SOLICITATION AMENDMENT
MODIFICATION DE L'INVITATION

Title - Sujet Integrated Soldier System Project	
Solicitation No. - N° de l'invitation W8476-112965/B	Amendment No. - N° modif. 022
Client Reference No. - N° de référence du client W8476-112965	Date 2013-07-11
GETS Reference No. - N° de référence de SEAG PW-\$\$RA-004-23669	
File No. - N° de dossier 004ra.W8476-112965	CCC No./N° CCC - FMS No./N° VME
Solicitation Closes - L'invitation prend fin at - à 02:00 PM on - le 2013-08-01	Time Zone Fuseau horaire Eastern Daylight Saving Time EDT
F.O.B. - F.A.B. Plant-Usine: <input type="checkbox"/> Destination: <input type="checkbox"/> Other-Autre: <input type="checkbox"/>	
Address Enquiries to: - Adresser toutes questions à: Scott, Sean	Buyer Id - Id de l'acheteur 004ra
Telephone No. - N° de téléphone (819) 997-5288 ()	FAX No. - N° de FAX () -
Destination - of Goods, Services, and Construction: Destination - des biens, services et construction:

This amendment is raised for the ISSP Request For Proposal (RFP) number W8476-112965/B.

Questions and Answers No. 97 to 107

G-WAGON DRIVER'S DOOR

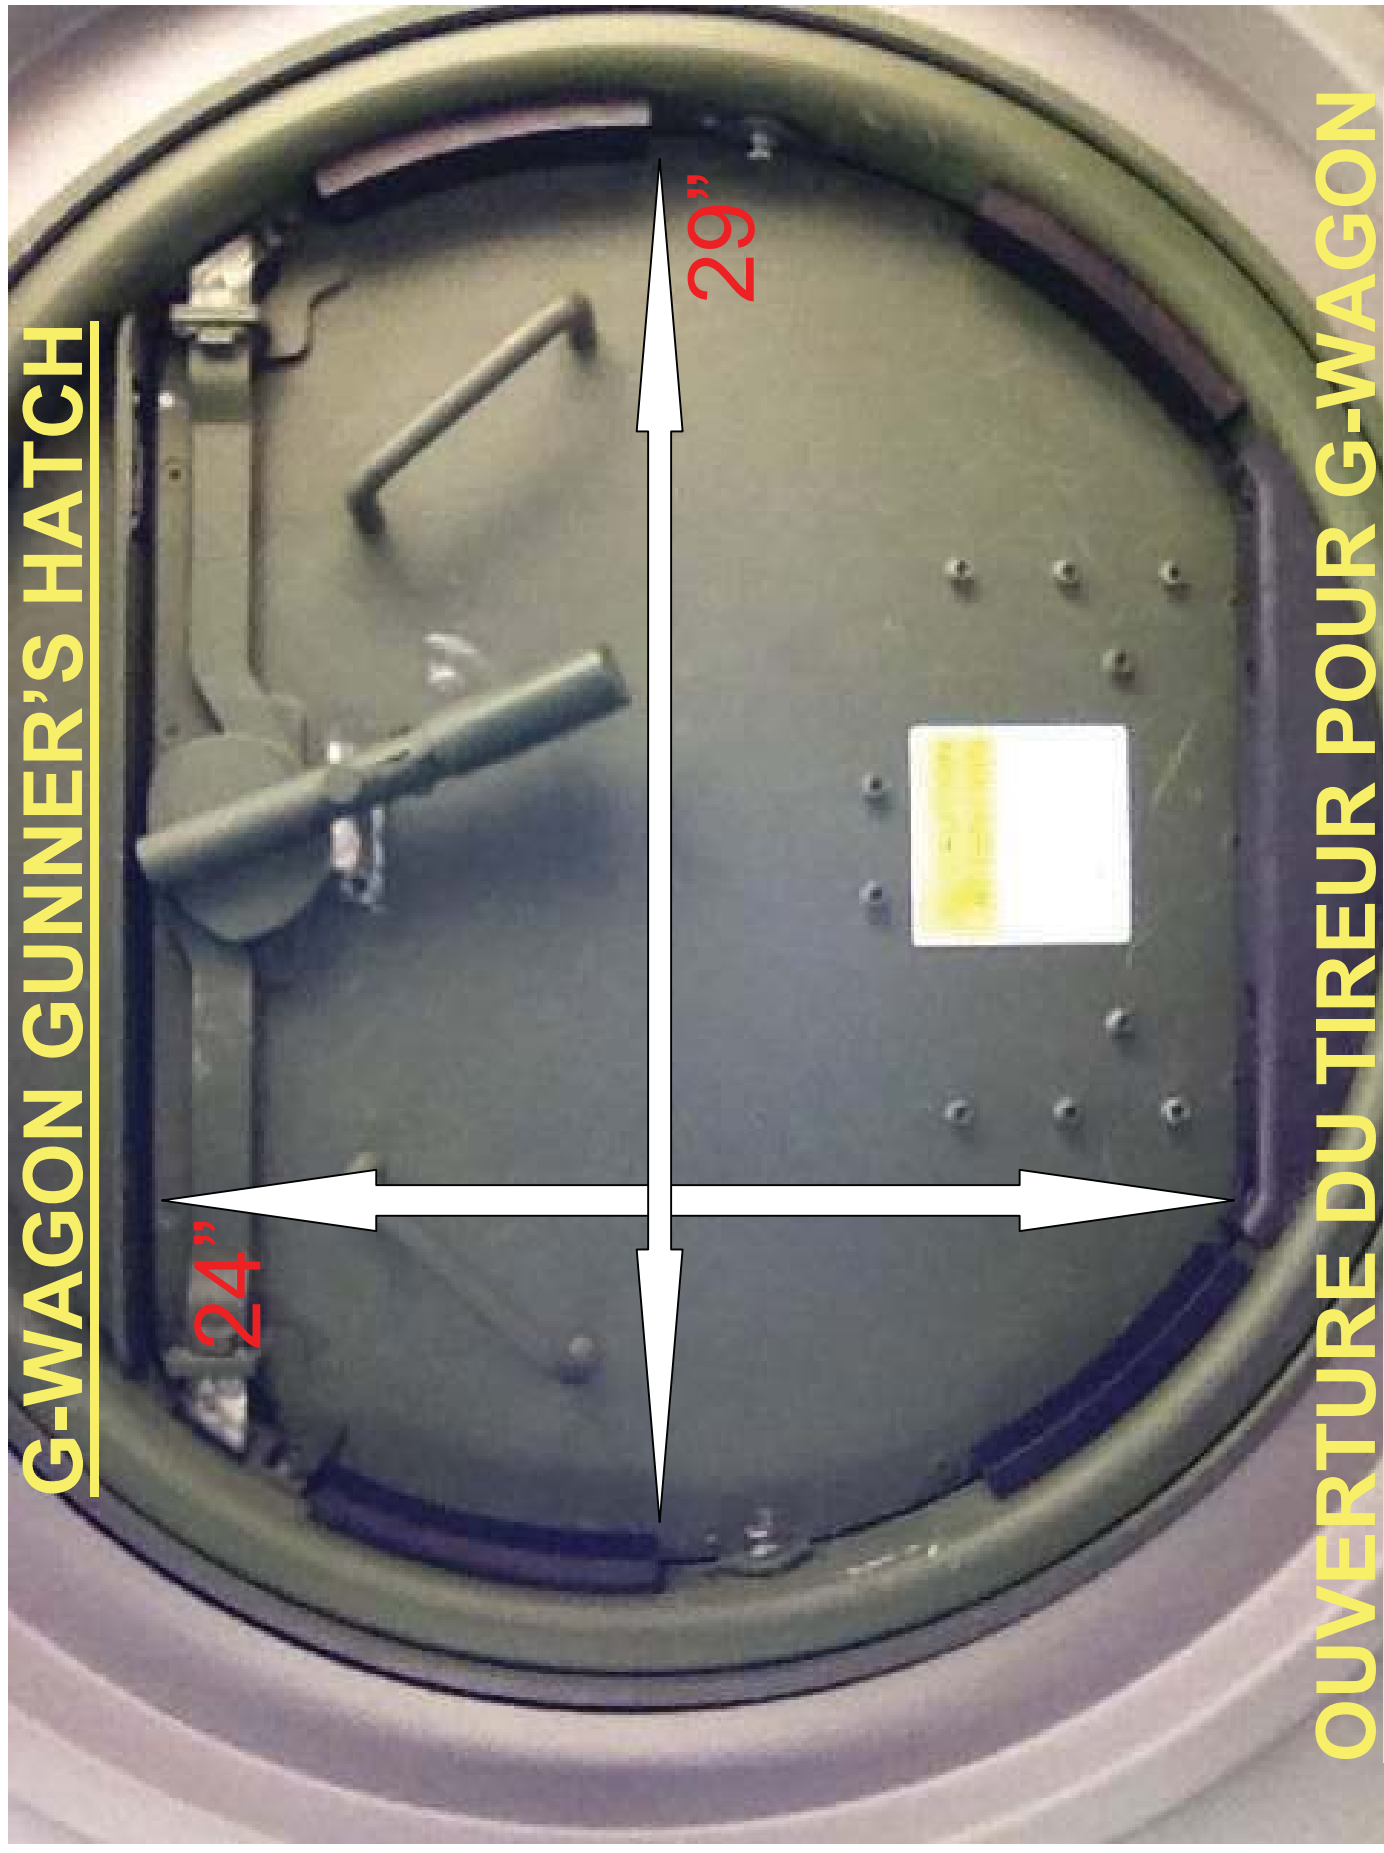
Q104: Could you point to or provide the dimensions for the hatches of the LAV III and G-wagon vehicles for the ISSP proposal.

A104: Attached you will find a bilingual version of the vehicle dimensions posters which were on display in the hallway during the Bidder's Conference held 1st May 2013.
